**Planning & Zoning Commission Agenda  
Rochester Boards & Commissions - Planning & Zoning Commission  
August 9, 2023  
6:00 p.m.**

**5.A. Interim Use Permit No.CD2023-001 to allow for excavation of bedrock located at 2660 Broadway Ave by Sawyer Construction Services Inc.**

**Request:** Interim Use Permit Request #CD2023-001IPU to allow for excavation of bedrock located at 2660 Broadway Avenue N.

**Development Review Team Recommendation: Denial**

**BEDROCK SLOPE EXACATION**

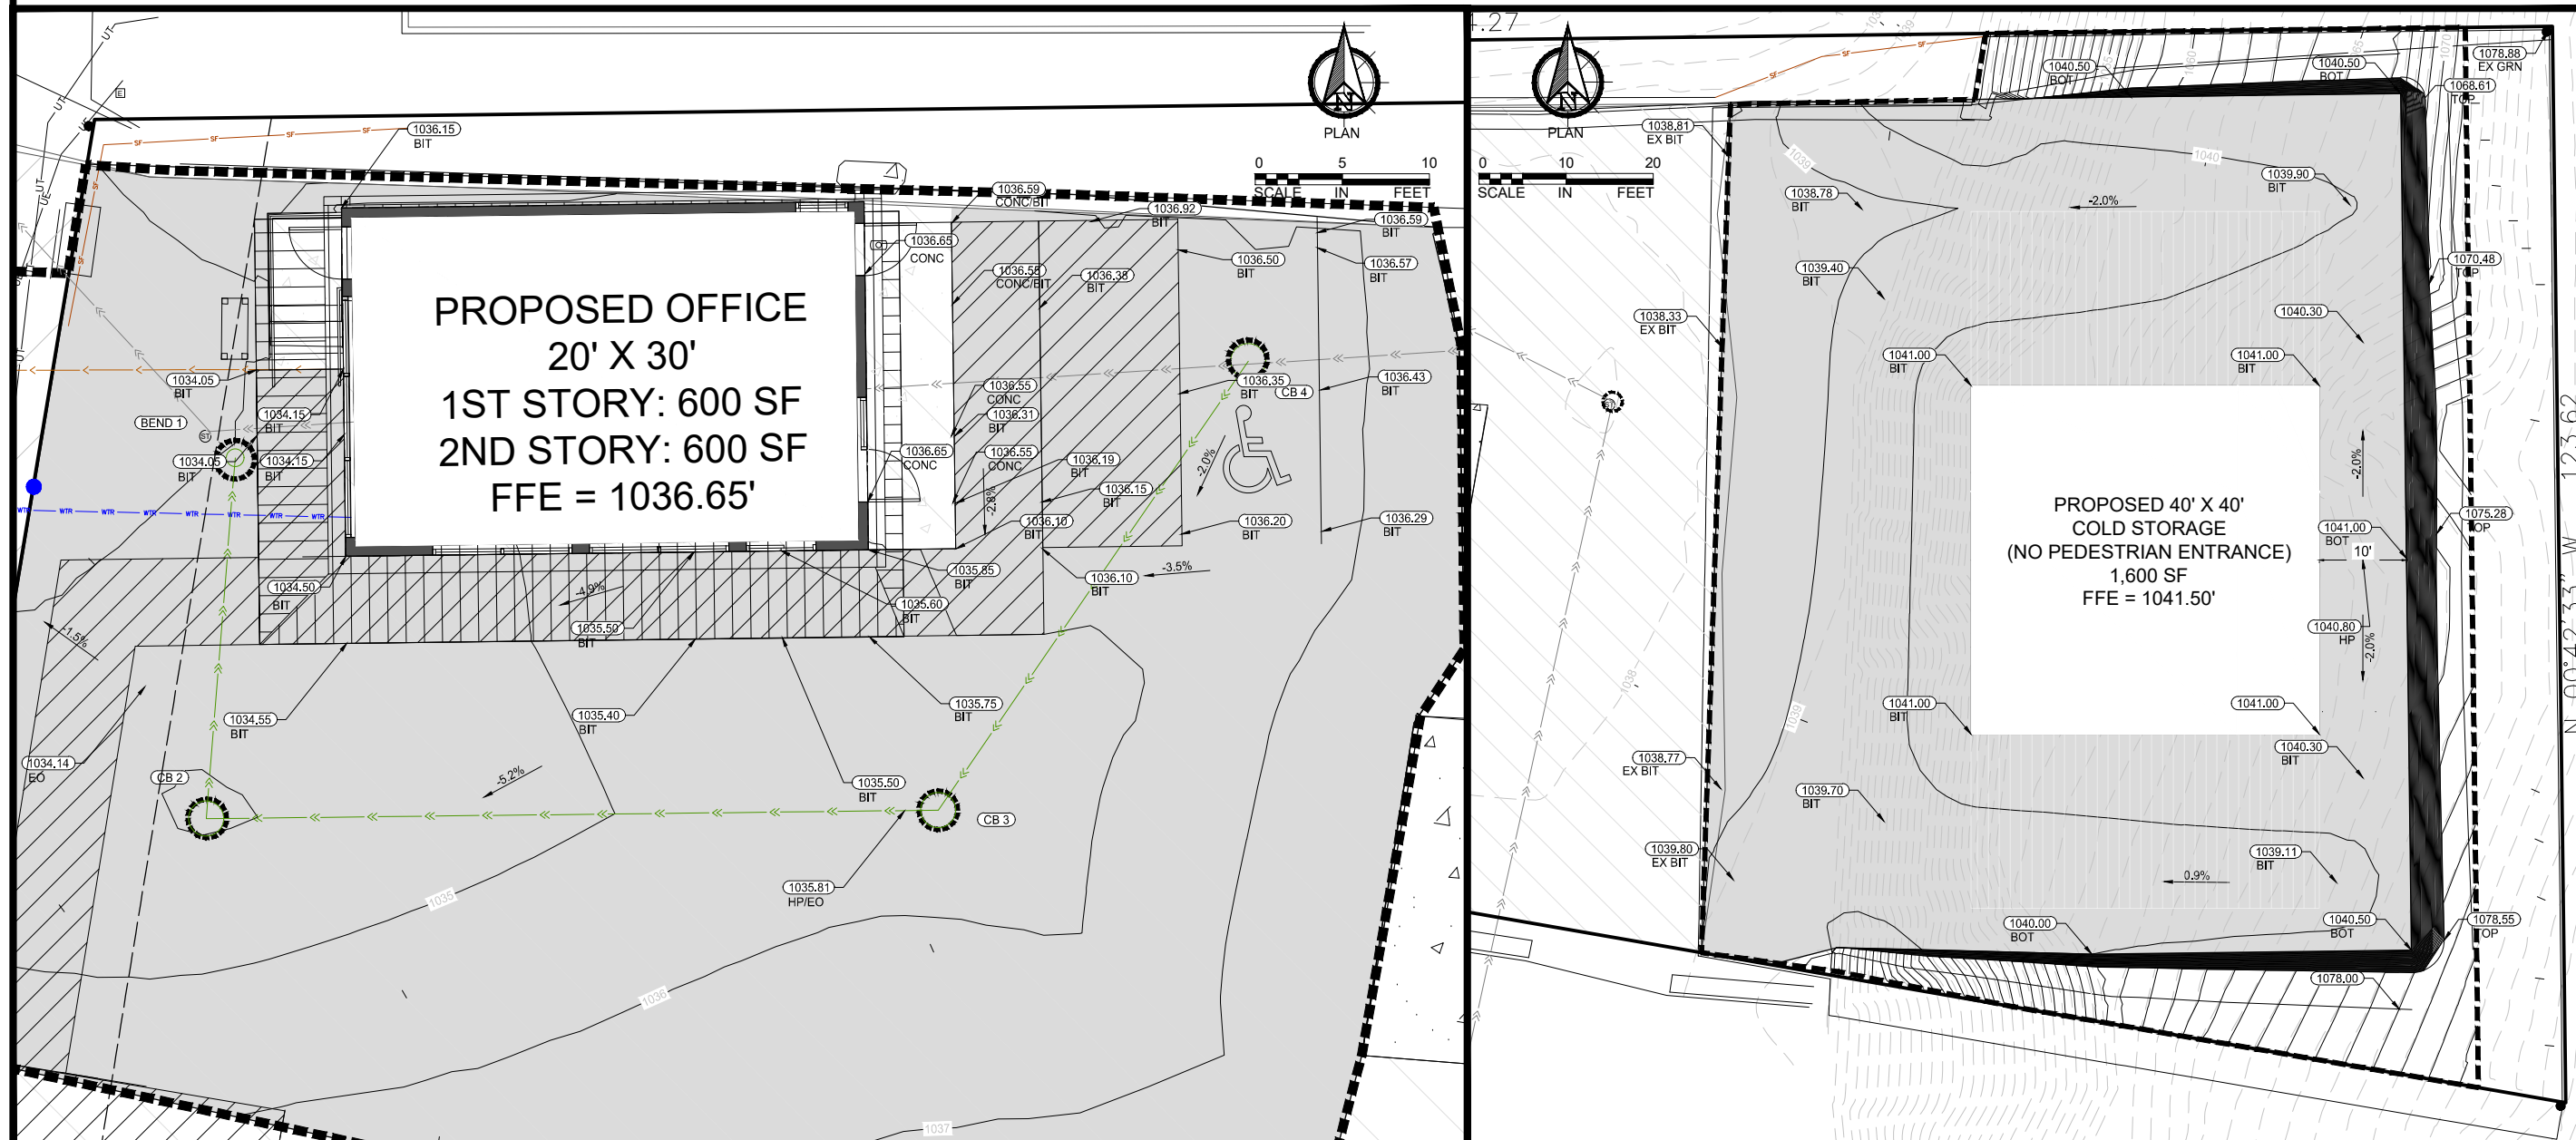
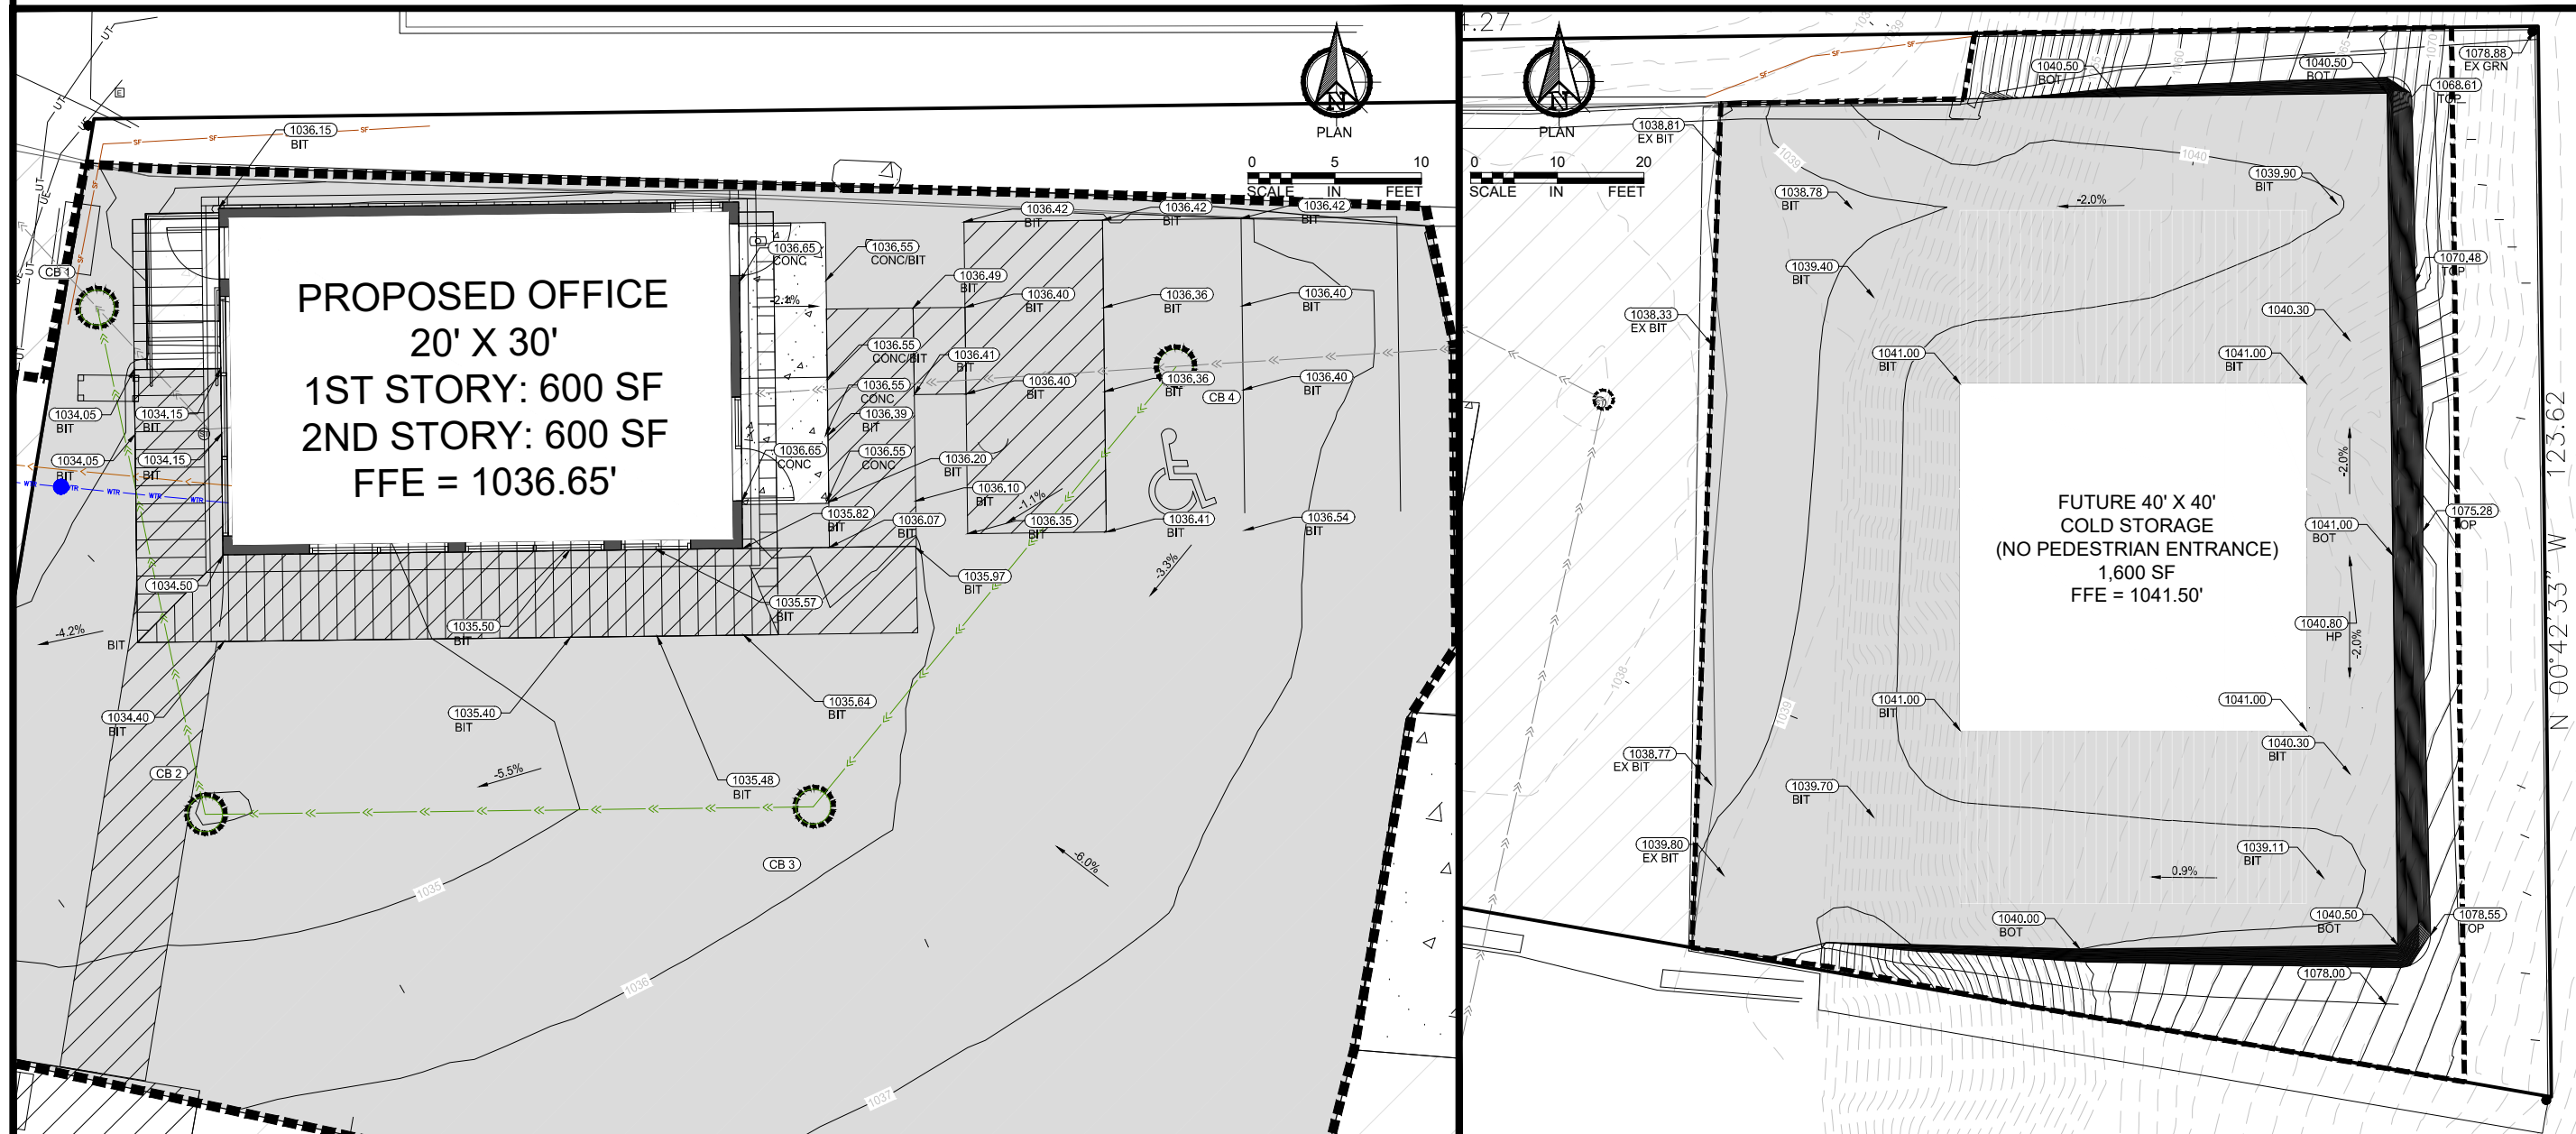
- ***All existing tall over-story trees located along the east property line above the proposed excavation must be removed.***
- ***Grading activity above the proposed excavation to the east property line may create unstable conditions for the soils that lie on top of the hill which can prompt sloughing.***
- ***Approximately 0.3 acres of offsite drainage is currently routed over the proposed excavation area. No provisions have been provided to accommodate this water within the site to prevent deterioration of the exposed rock face.***
- ***This proposed final grading is not consistent with neighboring parcels. The proposed plan maximizes the developable acreage within the parcel by excavating the hillside to the east and up to each adjacent property***

**boundary to the maximum extent possible. The proposed excavation creates near vertical rock faces that would expose all three adjacent properties to a risk of failure. Deterioration of the rock face will occur over time and possibly onto adjacent properties given the lack of a buffer.**

- **Concentrated flow from the top must be managed on the adjoining parcel to the east if the old quarry site is developed, which would require a water diversion or drainage catchment and drain tile above the proposed buffer yard on this parcel. It is necessary as to prevent any concentrated flows that could induce erosion or create a landslide hazard**
